## **Overview of potential sewerage and sewage treatment impacts from strategic development proposals for Redditch.**

8 November 2012  
Paul Hurcombe  
Severn Trent Water - Waste Water Strategy

Appendix A – Drainage Overview

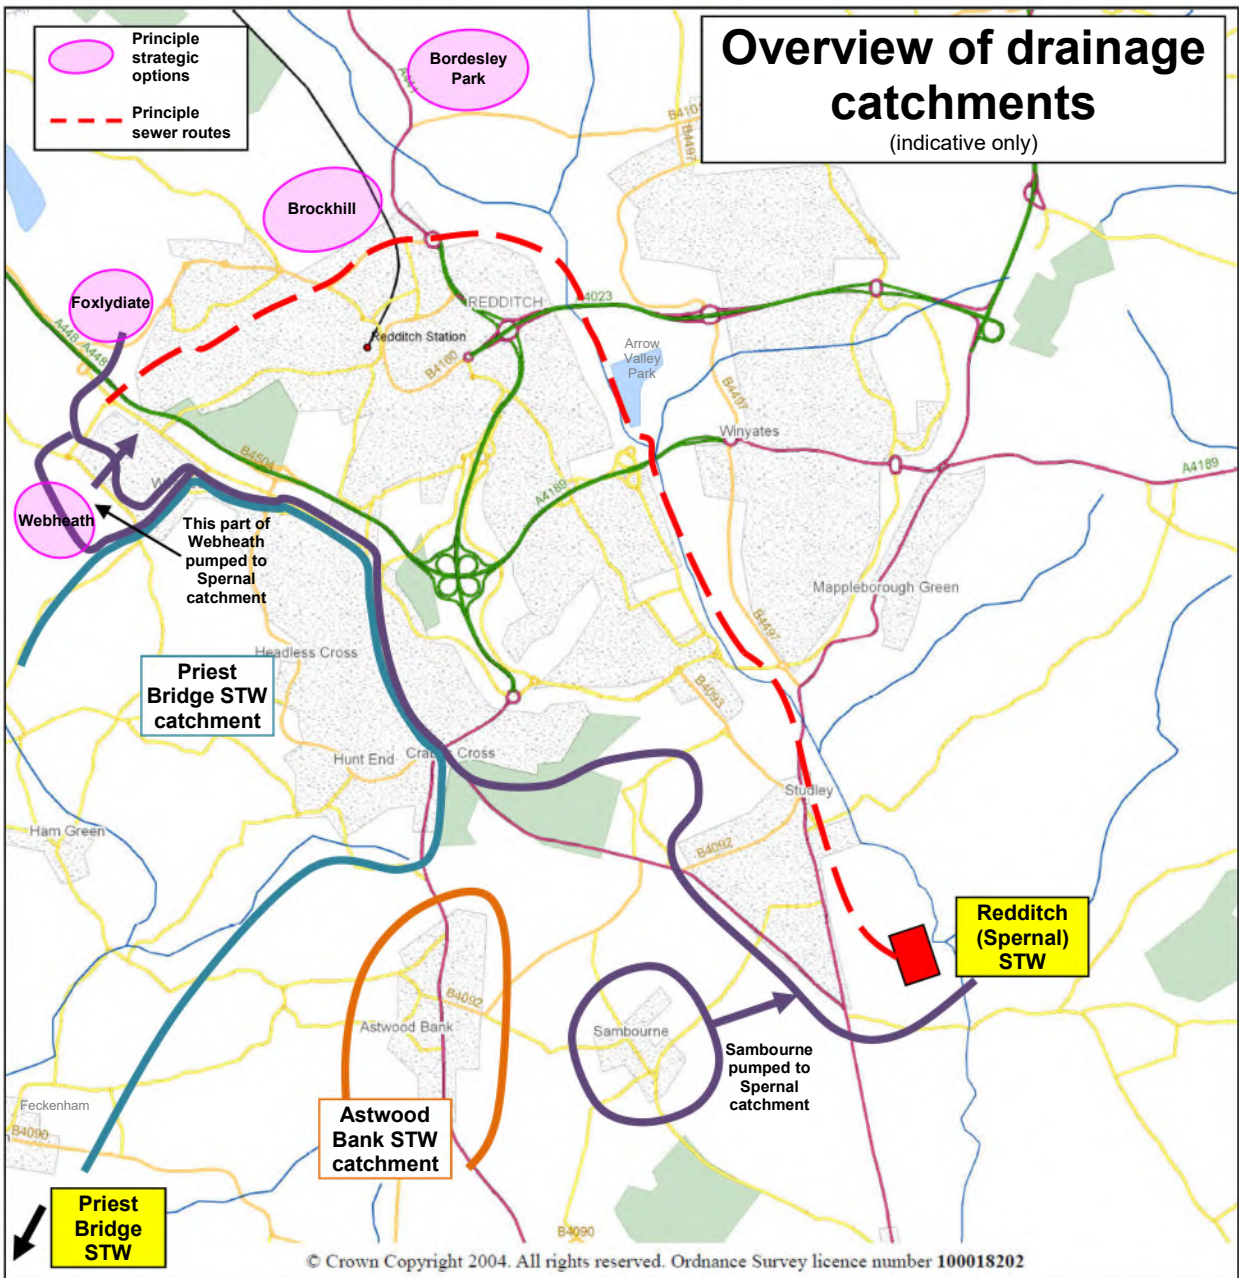
Due to topography Redditch is served by two sewerage catchments (See Appendix A).

The majority of Redditch is served by a gravity sewerage system which drains along the Arrow valley to a sewage treatment works at Spernal to the south east. Sections of the catchment in the Webheath area are connected to the Spernal catchment via pumping stations. Overall the catchment has good overall performance with a few localised capacity constraints but nothing significant for a catchment of this type.

The southern part of Redditch (Headless Cross, Hunts End and an area to the south of Webheath) drains south along a rural valley sewer that flows through Feckenham village before draining to Priest Bridge sewage treatment works. This system is known to have localised capacity issues in Feckenham.
